## CABINET MEMBER FOR ENVIRONMENT – 26 MAY 2020

## GRAFTON WITH RADCOT – A4095 AT PIDNELL BRIDGE -PROPOSED REVOCATION OF STRUCTURAL WEIGHT LIMIT

#### **Report by Interim Director of Community Operations**

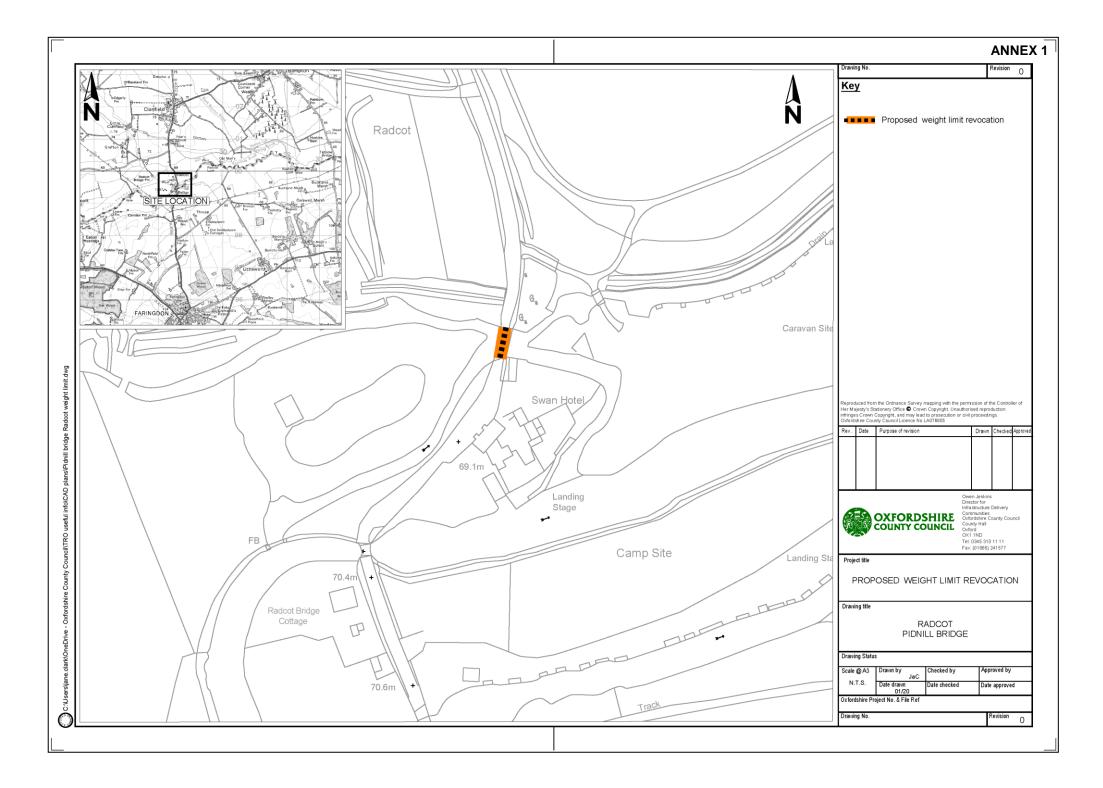
RESPONDENT	SUMMARISED COMMENTS
(1) Traffic Management Officer, (Thames Valley Police)	No objection – Please ensure you do not remove the weight limit signs for Radcot Bridge.

(2) Vale of White Horse District Council	No objection – No comments.
(3) West Oxfordshire District Council	No objection – No comments.
(4) Faringdon Town Council	<ul> <li>Object – At the recent planning committee members of Faringdon town council considered the revocation order and commented that the next bridge also has a weight restriction.</li> <li>Faringdon town Council felt that both should remain in place and would like to register their objection the removal of the weight restriction.</li> </ul>

(5) Local County Councillor, (Faringdon Division)	<b>Support</b> – I'm supportive of this if the strengthening work to the bridge has definitely strengthened it sufficiently to allow for the proposal to remove the existing weight limit and ensure safety.

(6) Local County Councillor, (Carterton South & West Division)	<b>Object</b> – Im worried as to the size of vehicles more than the weight, I feel if you remove weight limit you will get large vehicles, there are three bridges here two are very narrow with damage done to the brick work is always ongoing so I don't support this change

(7) Local Business, (Radcot)	<b>Object</b> – This move is bordering lunacy! There are already two actions being sought by the Trading Standards in respect of two vehicles that have damaged our property and become stuck on the following Radcot Bridge. I have contact names and emails if you wish to follow this up. I will of course, raise this with them directly too.

<ul> <li>There are already significant problems with groundings, caused by long-wheeled based vehicles attempting to cross Radcot Bridge. Although the current restriction relates to the weight of the vehicle, it follows that if the weight restriction is lifted, larger vehicles will attempt to cross the bridge, resulting in more groundings and subsequent periods of the road being closed. We have had serious damage to the bridge as well as walls knocked down and damaging cars in our carpark, there are currently two companies being taken to court for flouting the road signs.</li> <li>We have had the road shut in both directions on at least 5 occasions in the last year which include police attending the scene to redirect traffic, one lorry was stuck so severely it took over 6 hours to be released.</li> <li>We actually need more weight restrictions with less large and heavy vehicles coming through this direction.</li> </ul>

(8) Local Resident, (Radcot)	<b>Object</b> – The bridge has not changed shape of size, so longer lorries will still get stuck on it which causes traffic chaos in the surrounding areas, that combination of bridges does not enable large vehicles to cross it safely, please do not allow this to happen. Only a couple of nights ago there was chaos on that bridge due to a lorry that was too long trying to get over it

(9) Local Resident, (Grafton)	<ul> <li>Object – This bridge has had too many lorries getting stuck on it due to its narrow width and the way the road bends away from the bridge. If you take away the weight restriction, you will inevitably get larger lorries coming down the road and there is just no way they will be able to successfully get over the bridge. To my mind more weight means bigger lorries which will cost the council ie us the tax payer thousands to repair when the money should be going into road repairs etc.</li> <li>You really need to be discouraging large lorries using this road with bigger and better signs not encouraging them.</li> </ul>

(10) Local Resident, (Faringdon)	Object – Even with the existing weight restriction in place over Pidnell Bridge a number of heavy, long wheel-based vehicles ignore the warning road signs on the approach to Radcot Bridge from Clanfield regarding the weight restrictions and proceed onto the Radcot Bridge. The turn is impossible for long wheel-based vehicles and they become stuck and grounded - blocking access over Radcot. The delay in getting these vehicles moved off the Bridge is significant, exacerbated by the damage that removing them inevitably causes to the Bridge.         It seems inevitable that, if the current weight restriction is lifted, drivers of heavier vehicles will assume that the Radcot Bridge is now accessible. It's not. It cannot carry long wheel-based vehicles. Surely all that's going to happen is that

<ul> <li>heavier vehicles will become stuck between Pidnell Bridge and Radcot Bridge - being unable to pass over the latter.</li> <li>Or they will attempt to cross and become grounded causing more damage to the road, margins and verges in attempting to turn around.</li> <li>I strongly object to this Weight Limit Revocation.</li> </ul>
	<b>Concerns</b> – I am very concerned about this proposal and the indirect consequences this change could have. I have witnessed many long and heavy commercial vehicles either grounding out or battering into the historic bridge parapet walls. Invariably this causes gridlock, the severity of which is increasing constantly as new house building in the area attracts more cars to the A4095.

(11) Local Resident, (Radcot)	The current weight limit on Pidnell bridge assists in deterring long vehicles from attempting the crossing of the Radcot Thames bridges. The logic is that most long vehicles are also heavy. With the weight limit in place Pidnell acts as a defence for problems that long will regularly have (sometimes daily, most definitely weekly).
	Before lifting the weight limit on Pidnell bridge please do more to deter long vehicles from coming to Radcot. Once new deterrents are established and proven to work, then lift the weight limit on Pidnell?

- 10. It should be stressed that the proposal is only to revoke the existing structural weight limit of 6 tonnes at the A4095 Pidnell bridge, which is not required following bridge strengthening works and which cannot reasonably be continued. The existing 7.5 tonne environmental weight limit will, however, remain in force and, therefore, there should be no increase in the number of goods vehicles using the route as the result of the revocation of the structural weight limit.
